# Service Bulletin

**SUBJECT:** Service Update for Inventory and Customer Vehicles  
Starter Motor Damage Due to Positive Battery Cable and Starter Solenoid  
Terminal Contact  
Expires with Base Warranty

**MODELS:** 2013 Chevrolet Sonic  
U.S. Vehicles Only

Subject: 12289 – Service Update Bulletin  
Starter Motor Damage Due to Positive Battery Cable and Starter  
Solenoid Terminal Contact

3136617

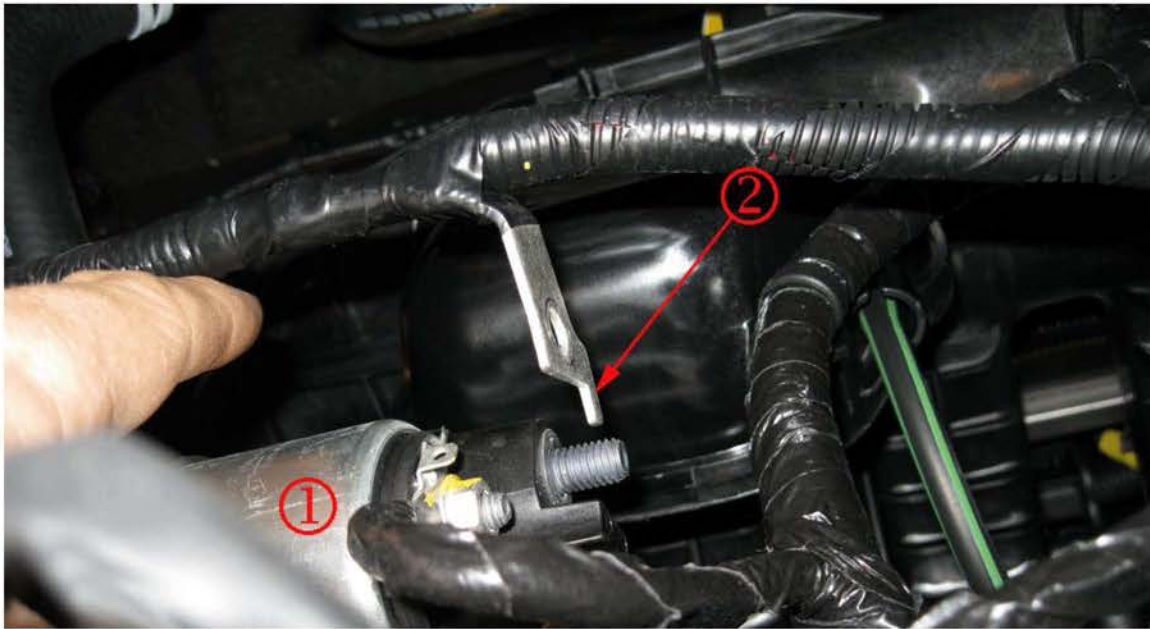
3. Locate the starter solenoid (1), positive battery cable terminal (2) and positive battery cable fastener (3).

3136868

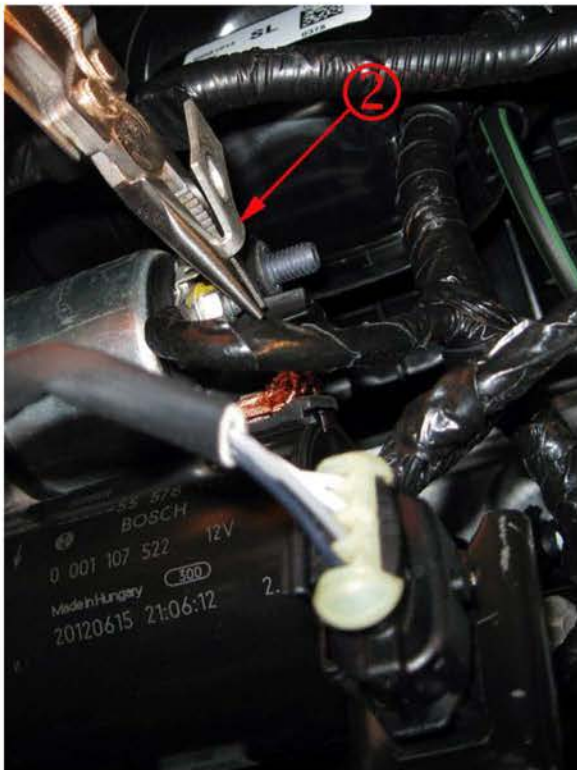
4. Remove the positive battery cable fastener and the positive battery cable terminal (2), from the starter solenoid (1).

5. Using pliers bend the positive battery cable terminal tab (2) 90 degrees inward as shown in illustration.

**Note:** Do NOT allow the battery positive cable terminal tab to rotate clockwise on the starter solenoid while tightening the battery positive cable terminal fastener. Hold the positive battery cable terminal tab down (counter clockwise) while tightening the positive battery cable terminal fastener.

6. Install the positive battery cable terminal and fastener to the starter solenoid.
7. Tighten the positive battery cable terminal fastener to 9 Nm (80 lb-in).
